CALIFORNIA COASTAL COMMISSION

STAFF REPORT: REGULAR CALENDAR**APPLICATION NO.:** 4-93-206**APPLICANT:** John Stevens**AGENT:** Sherman Stacey**PROJECT LOCATION:** 31333 Mulholland Highway, Malibu, Los Angeles County

PROJECT DESCRIPTION: Subdivision of 80 acres developed with one single family residence into 6 lots, ranging in size from 10-acres to 15-acres, with 67,300 cu. yds. of grading (34,500 cu. yds. cut and 32,800 cu. yds. fill) to construct access driveway and 5 building pads, each over one-half acre in size.

EXHIBIT 3
 4-93-206
 GRADING
 PLANS- Lots
 4, 5, and 6

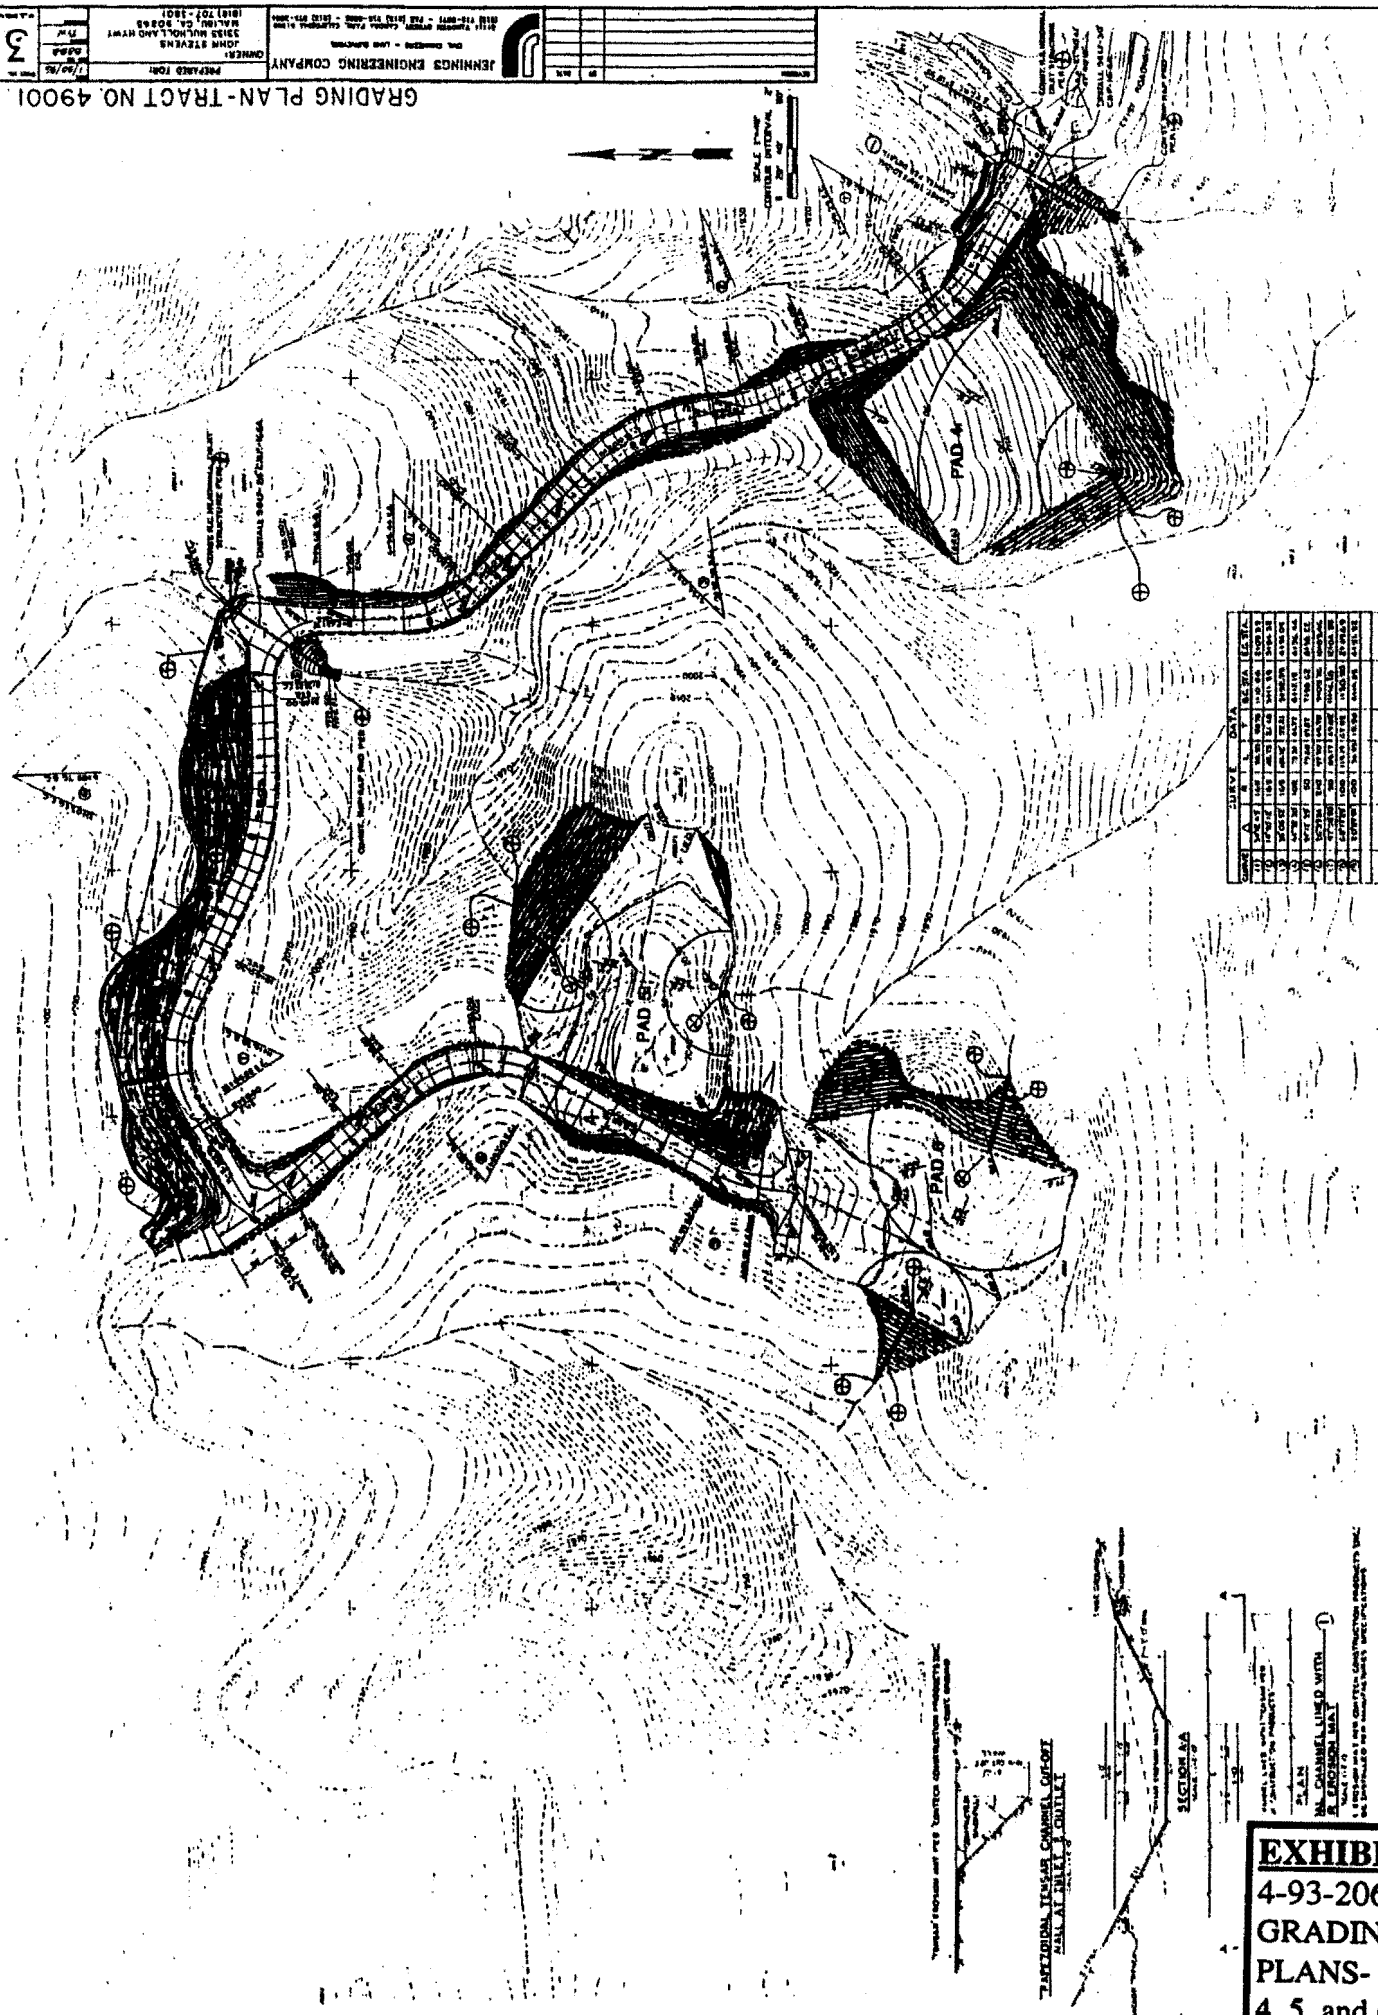
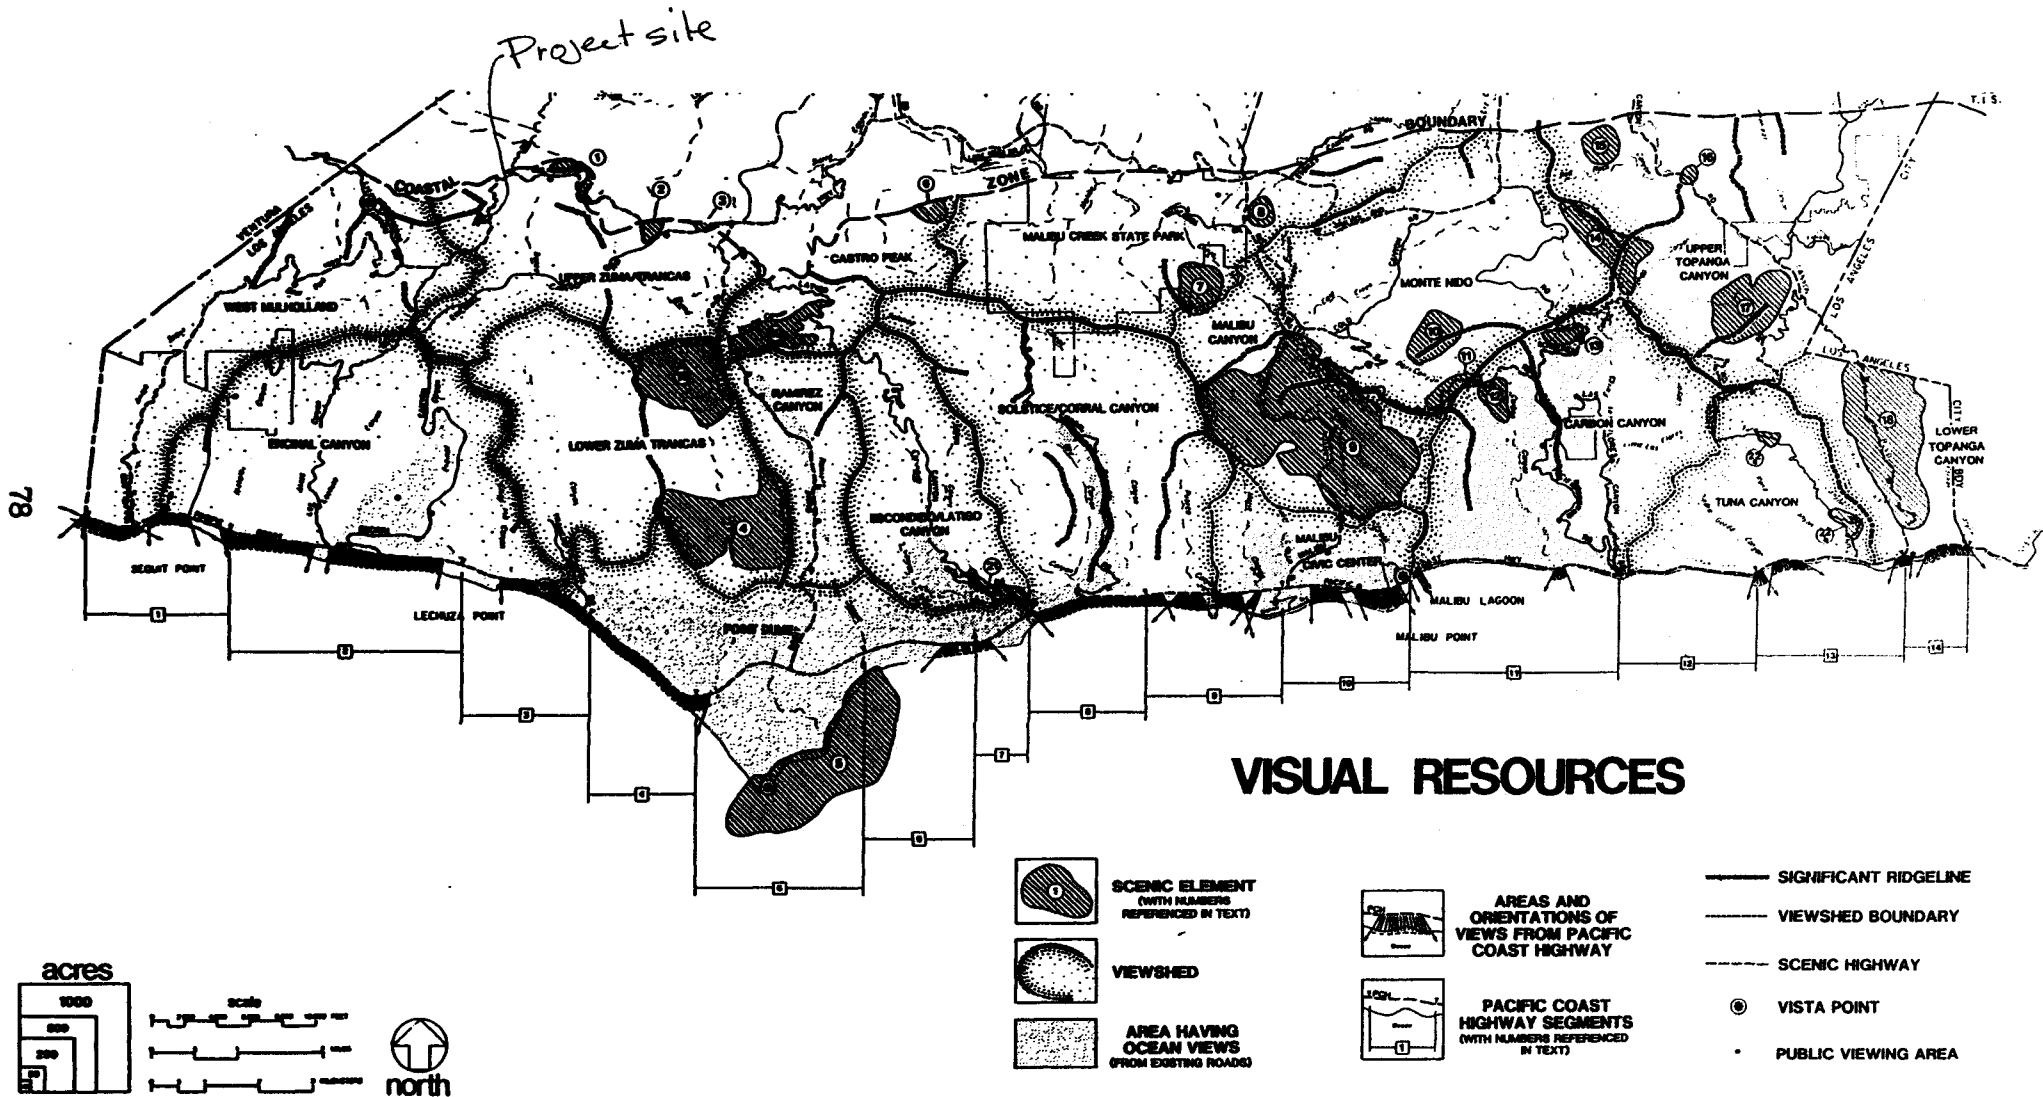
The applicant proposes 13,000 cu. yds. of grading for construction of the building pad on Lot 4. This grading would involve a fill slope with an elevation change of 28 feet and that would run 70 feet from top to bottom at the highest point. This fill slope would be located on the downslope edge of the pad. The cut slope above the pad would have a 22 foot change in elevation and a run of 40 feet. The resultant pad would be square in shape. The roadway improvements from the existing access road to Lots 4, 5, and 6 would require 7,500 cu. yds. of grading and would include cut slopes with over 35 feet of elevation change and with a run of 60 feet from top to bottom. Finally, the pads on Lots 5 and 6 would require 23,300 cu. yds. of grading (combined). Lot 5 would require the construction of a 55 foot long fill slope while a 60 foot long cut slope is proposed for Lot 6.

The proposed building pad for Lot 4 is also very large in size and involves 13,000 cu. yds. of grading. This pad would be 24,500 sq. ft. in size, would be square in shape and would include slopes of 40 feet (cut) and 70 feet (fill) in length. Lots 5 and 6 would require a significant amount of grading to construct (23,300 cu. yds.). While the County of Los Angeles did require the applicant to retain two knoll features in order to screen the pads from Mulholland Highway, these two pads would still be visible from public trails and from Decker Canyon Road. Each pad would be 28,000 sq. ft. in size. Additionally, 7,500 cu. yds. of grading and cut slopes of 60 feet in length would be required to improve the access road to the western area of the site. As previously noted above, this large flat pad design does not blend with the natural landforms on site and clearly does not minimize grading and landform alteration as required by Section 30251 of the Coastal Act. Although the proposed pad for Lot 2 would be 28,000 sq. ft. in size, the pad is located on a flatter area of the site and would require less grading (5,500 cu. yds.) and smaller slopes to construct. Additionally, this pad is located on a lower area of the site and would be much less visible than the other proposed pads.

In this case, the most obvious alternative would be for the applicant to reduce the size of the proposed building pads. With this modification, there would be a commensurate reduction in the amount of grading and in the overall height and length of the proposed manufactured slopes, consistent with LUP policies P82, P90, P91, P130, P134, and P135. Along with a reduction in size, the proposed pads could be redesigned to more closely conform to the natural terrain of the site. Large, rectangular pads are not consistent with the terrain of the project site. Contour grading techniques could be utilized so that the pads would blend more with the natural topography, consistent with LUP policy P134. Split level pad design could be implemented to reduce overall grading. Additionally, several of the proposed parcels could be designed for future residences that would be built to the existing slope as much as possible, with just enough grading to construct a driveway and fire department turnaround area, thereby significantly reducing landform alteration. These measures could be implemented to redesign the proposed project to minimize the alteration of natural land forms, consistent with Section 30251 of the Coastal Act. Houses of significant size could still be constructed on smaller pads, while minimizing impacts to visual resources.
